PLANNING BOARD AGENDA
JANUARY 13, 2016 – 7:00 P.M.

RE: **PCSB Site Plan**
Route 6
Tax Map No. 86.11-1-1 – Proposed Lot 1

RE: **Route 6 Retail Site Plan**
Route 6
Tax Map No. 86.11-1-1 – Proposed Lot 2

DRAWING: **VEHICLE MANUEVERING PLAN -
SINGLE UNIT TRUCK**

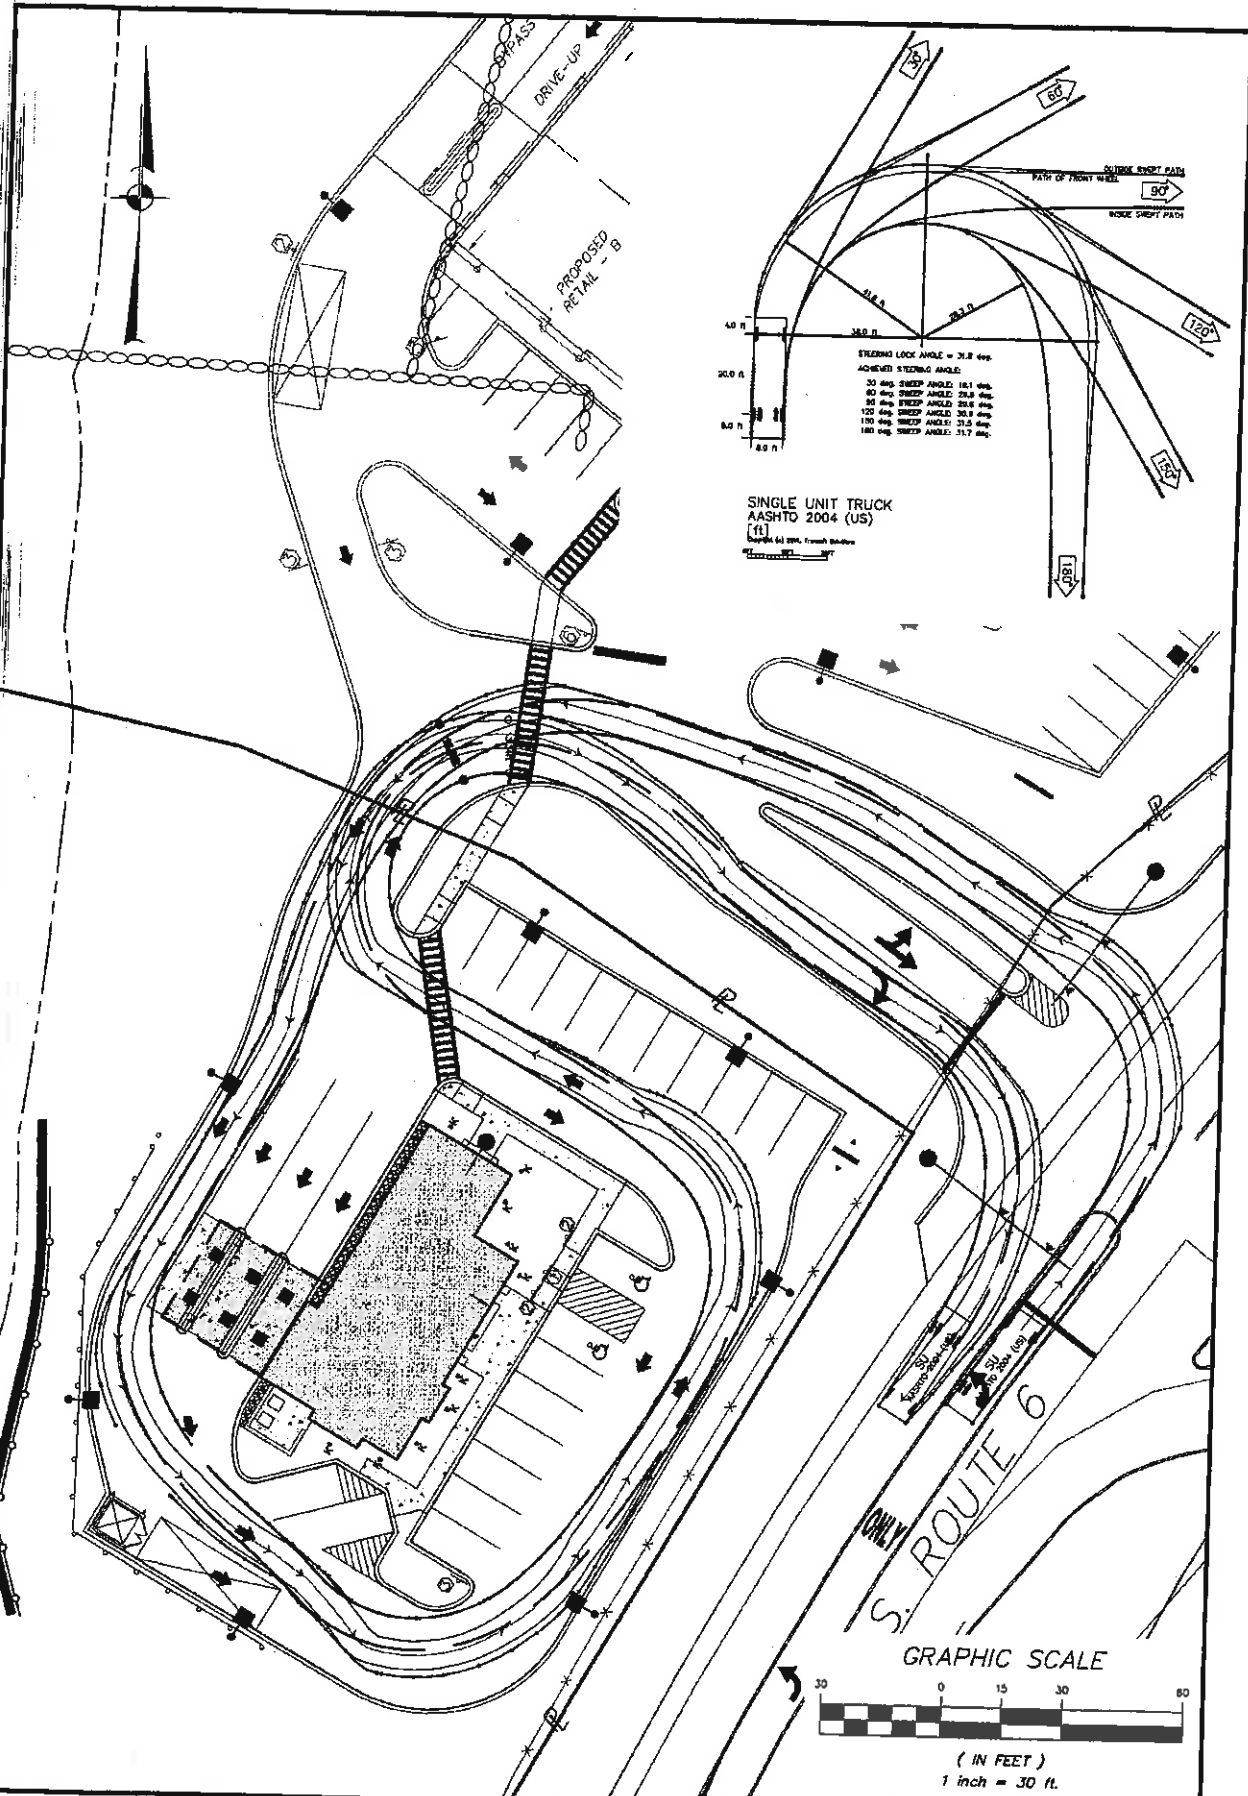
- 1. Overall Plan – OP-1
 - a. Response provided in enclosed memorandum prepared by Maser Consulting P.A. dated December 18, 2015.
 - b. A graphic representation of vehicle movements through the site for a passenger vehicle and a single unit truck have been provided on Drawing D-1.

DRAWING NO.: OP-1
SHEET: 1/1

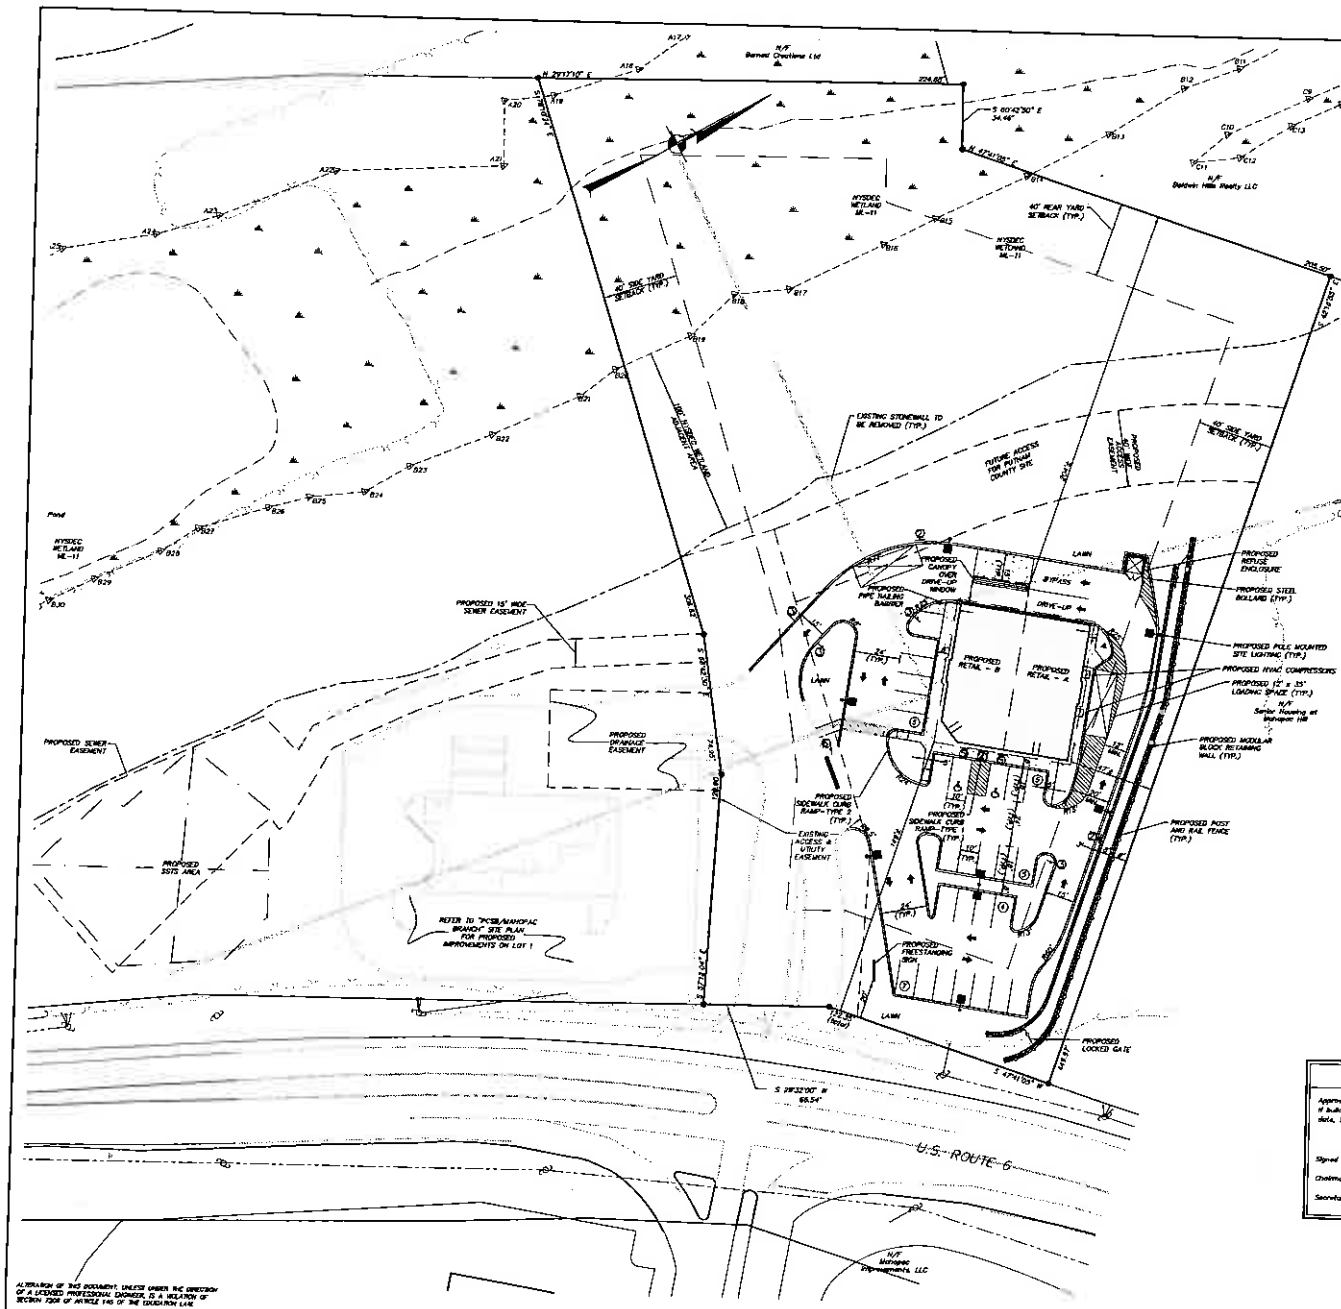
- 1. Overall Plan – OP-1
 - a. Response provided in enclosed memorandum prepared by Maser Consulting P.A. dated December 18, 2015.
 - b. A graphic representation of vehicle movements through the site for a passenger vehicle and a single unit truck have been provided on Drawing D-1.
 - c. The parking spaces and driveway aisles have been designed to meet the Town code requirements. In addition, an additional study has been provided for passenger vehicle movement through the site.
- 2. Layout and Landscape Plan – SP-1
 - a. The easements for site access, SMPs and utilities are shown on the plan. Agreements/easements will be provided in a later submission.

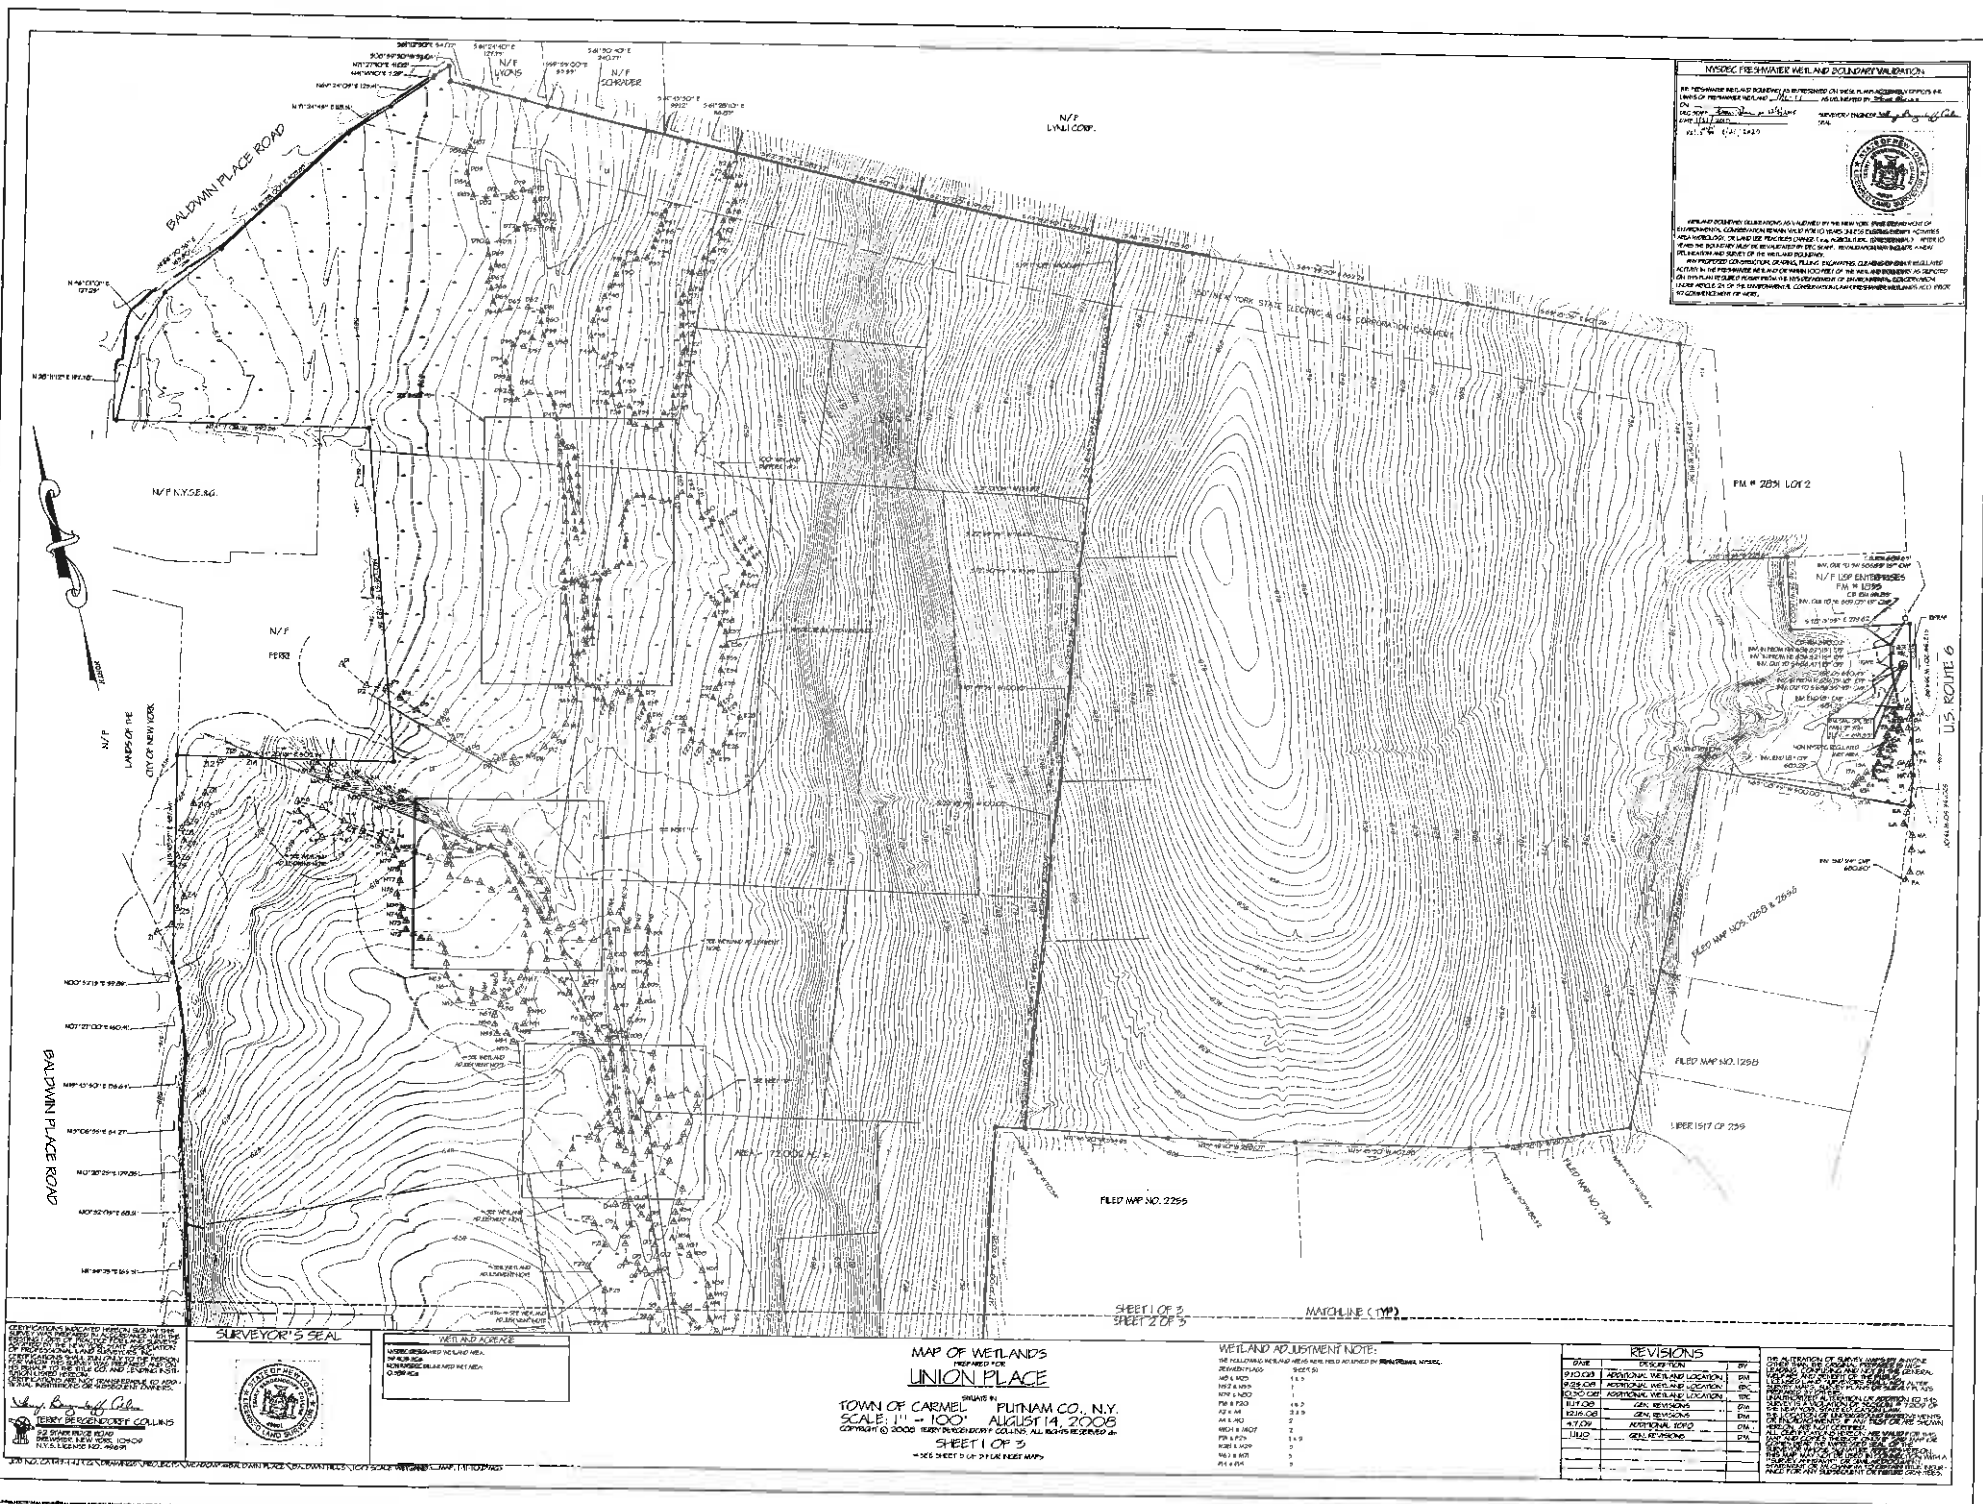
8. Figure G-2 has been included in this submission to show the overall concept grading for the possible future driveway connection to the Kohler Center. As shown in the grading study, the connector driveway would tie into an existing paved driveway at the Kohler Center.
